MEMORANDUM

SUBJECT: **CAMPO 2040 Regional Transportation Plan, City of Austin Staff comments**

City of Austin staff comments on the CAMPO 2040 Plan

Project Title: CAMPO 2040 Plan

Map 1

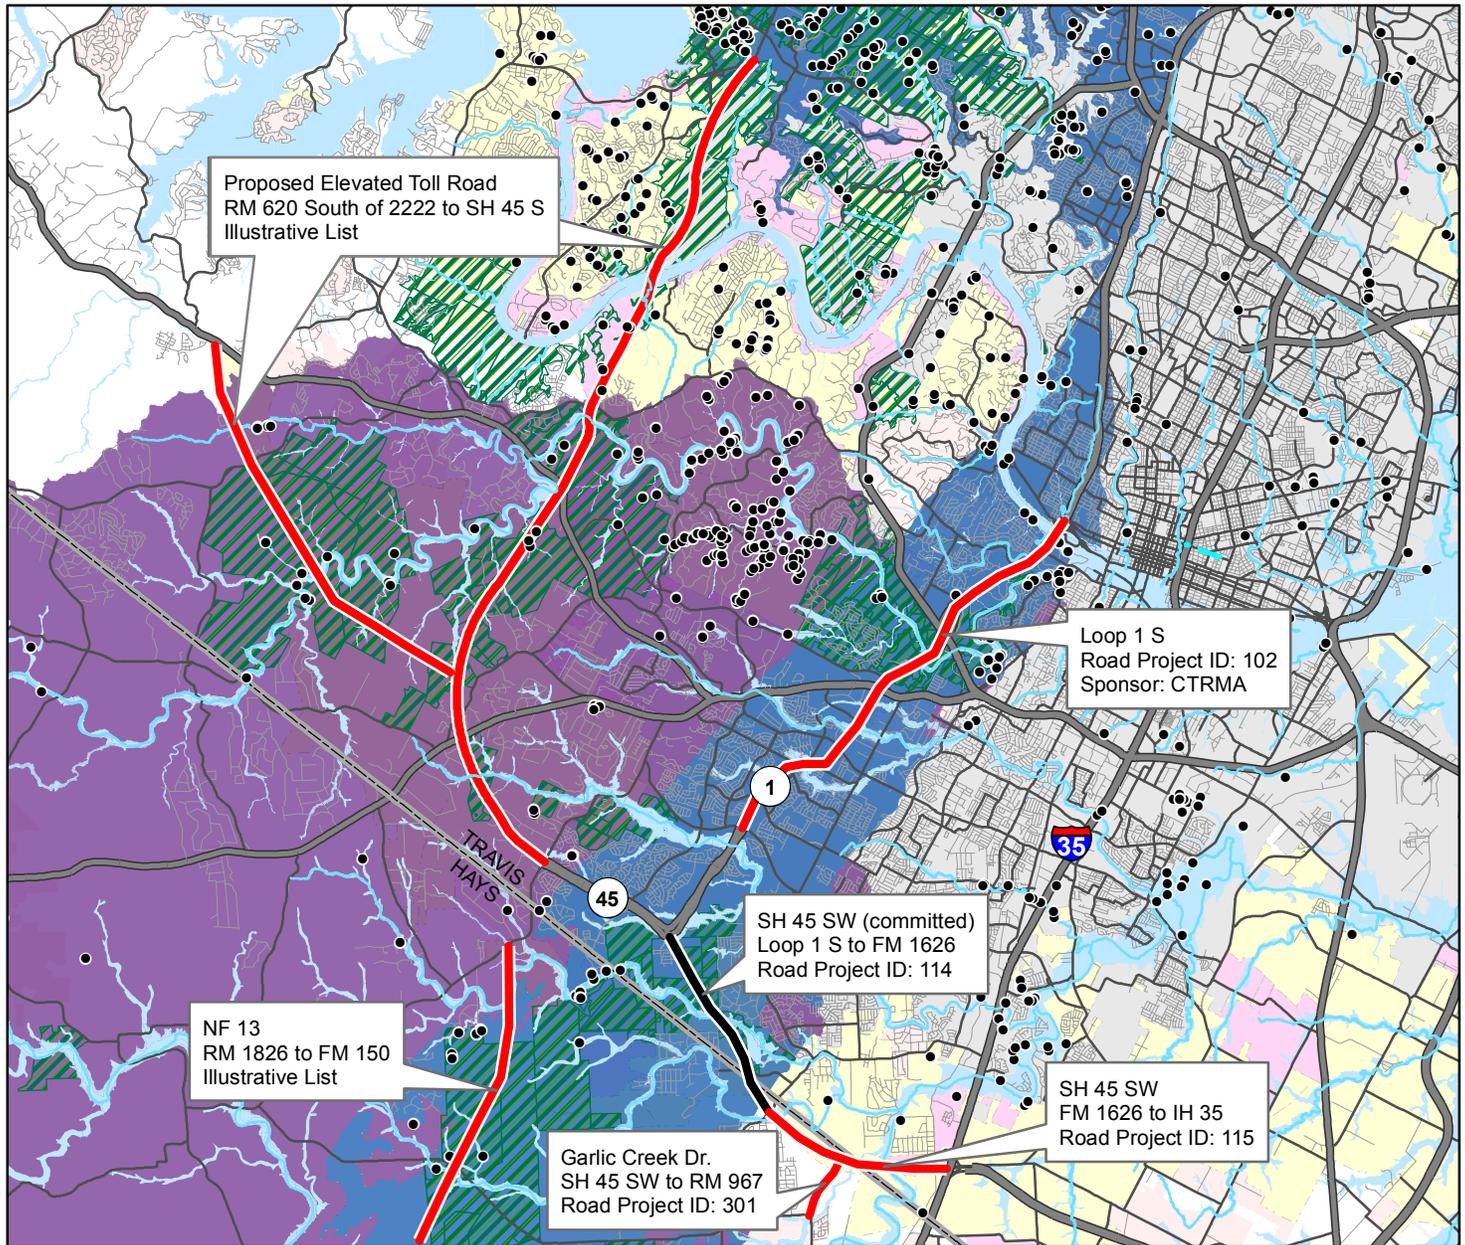
City staff generally concurs with the projects contained within the CAMPO 2040 *Regional Transportation Plan*. However, based on City policy, enumerated in the *Imagine Austin Plan Comprehensive Plan* and subsequent Council actions, staff will continue to request objection to SH 45 and related projects included in the 2040 Plan. These projects, as well as others proposed in environmentally-sensitive areas, are illustrated in *Map 1* and outlined as follows:

- **Loop 1, Cesar Chavez to Slaughter, Road Project ID: 102, Sponsor: CTRMA, page 167**
This project is described as increasing the capacity of Loop 1 South with two express lanes in each direction. This differs from what was in the previous, CAMPO 2035 *Regional Transportation Plan*, which proposed the project as only one express lane in each direction. City staff has serious concerns regarding the technical feasibility of the project and the evaluation of the impacts of the project on connecting roadways, as well as the environmental implications of the surrounding area. Moreover, the project is entirely in the City of Austin and Travis County jurisdictions, and as such, City Council should be given the opportunity to understand the proposed project changes. Therefore, city staff will request that the 2040 Plan definition remain consistent with the definition in the CAMPO 2035 Plan (one express lane in each direction) until an agreement can be reached with the jurisdictions in which the proposed project is located.

- **SH 45 SW, Loop 1 S to FM 1626, Road Project ID: 114, Sponsor: CTRMA/TxDOT, page 168**
Described as a four-lane tolled freeway with a 2015 Let Year, which is the year that funding is available for a project. This is the Committed, controversial SH 45 SW that was recently cleared by TxDOT to proceed into final design and construction. This project is in direct conflict with *Imagine Austin*, which states under Action LUT A46, "Ensure consistency between the Growth Concept Map Series and regional transportation plans by amending the Austin Metropolitan Area Transportation Plan to remove SH45 SW and requesting its removal from the Capital Area Metropolitan Planning Organization 2035 Regional Transportation Plan."

- **SH 45 SW-E, FM 1626 to IH 35 S, Road Project ID: 115, Sponsor: Hays County/Buda, page 168**
This project is described as the environmental and preliminary engineering analysis for SH 45 SW, from FM 1626 to IH 35. This piece would complete SH 45 SW from IH 35 and Loop 1 S, and falls within the City of Austin's extraterritorial jurisdiction (ETJ). This is inconsistent with *Imagine Austin*, as noted above, and the City is on record in opposition to SH 45 SW in this area.

- **Garlic Creek Dr., SH 45 SW to RM 967, Road Project ID: 301, Sponsor: Buda, page 178**
This project is described as a new, four-lane divided roadway that would be 100% Locally Funded, with a 2025 Let Year. While only a small portion falls within the City's ETJ, this project would provide a new north/south thoroughfare that would connect to SH 45 SW between FM 1626 and IH 35 (Road Project ID 115), which is inconsistent with policy noted in *Imagine Austin*.

- **Proposed elevated Toll Road, RM 620 South of 2222 to SH 45 S, Illustrative List, Sponsor: Lakeway, page 205**, The proposed project is similar to the 1984 “SH 45 Western Outer Loop”, and is a study in the Illustrative List for a six-lane, elevated toll road. Any new roadway would traverse through the City’s full-purpose jurisdiction and ETJ, require a new western bridge over Lake Austin, and cross City of Austin Water Quality Protection Lands (WQPL) and areas designated in the Balcones Canyonlands Conservation Plan (BCCP). This project also has significant federal permit implications and could severely impact environmentally sensitive areas and protected species. While the Austin Transportation Department (ATD) is on record for objecting to this project, the City of Austin’s Watershed Protection Department and Austin Water Utility would also like to emphasize that they too do not support this project due to environmental issues and constraints. *Map 1* demonstrates the project is contrary to *Imagine Austin* and City staff will request that it not be considered for further study. Austin Transportation Department (ATD) staff requests that alternative, existing roadways be considered for further study to address the mobility concerns of this area (e.g. Loop 360, RM 620, RM 2222, and SH 71).

- **NF 13, RM 1826 to FM 150, Illustrative List, Sponsor: Hays County, page 208**
This project replaced what would have been the Escarpment extension to connect SH 45, west of Loop 1 S, to FM 150 in Hays County. This project is presently described as a **new**, two-lane undivided, major arterial, which would provide a north/south connection between RM 1826 to FM 150. While much of the proposed project falls outside of City of Austin jurisdiction, it would traverse through the City’s Water Quality Protection Lands and/or Conservation Easements that are protected in perpetuity, thus negatively impacting the City of Austin. City staff has pointed this out on multiple occasions and continues to request that this project be removed.
